ADDENDUM #1

Project: Plamondon Village Square Development
Date: March 19, 2025
Page: 4 of 4

Our File: 32325
Closing: Tuesday, March 25th, 2025
12:00:00 noon local time

Figure 1.0
THICKENED SLAB
LOCATIONS

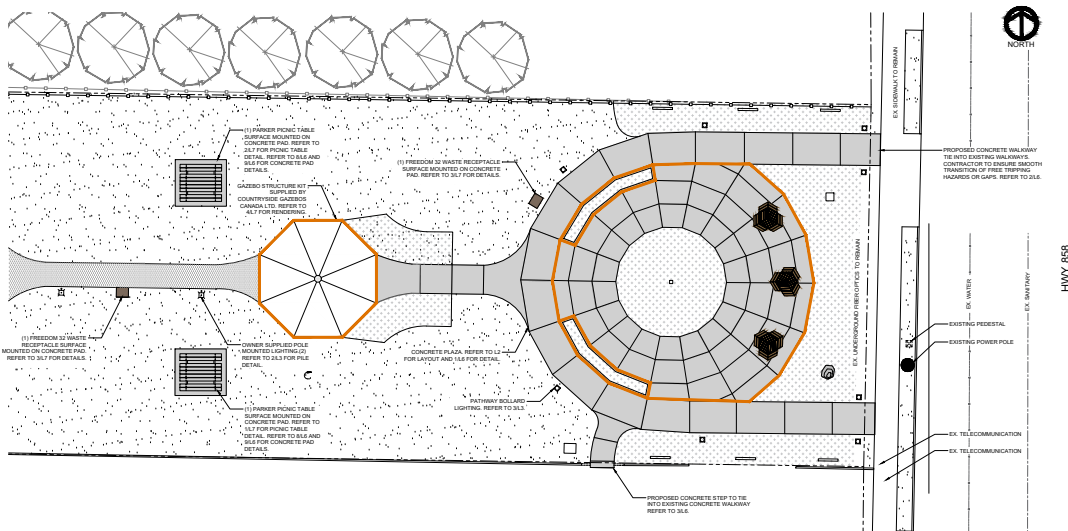
Item 4.02 – Supply and install 100mm concrete. Is this to read 150mm as per drawings? And does all concrete have a thickened edge?

Pay item 4.02 notes that concrete for sidewalk is 100mm depth, but detail 1 on L6 notes 150mm depth with thickened edges. Can we receive clarification on this?

Concrete to be 150mm thick. Refer to the image below showing where thickened edges are required, shown in orange

Refer to Page 1 of the addendum, MODIFICATIONS TO TENDER DOCUMENTS. Concrete to be 150mm depth, and thickened edges in locations as shown in Response #15
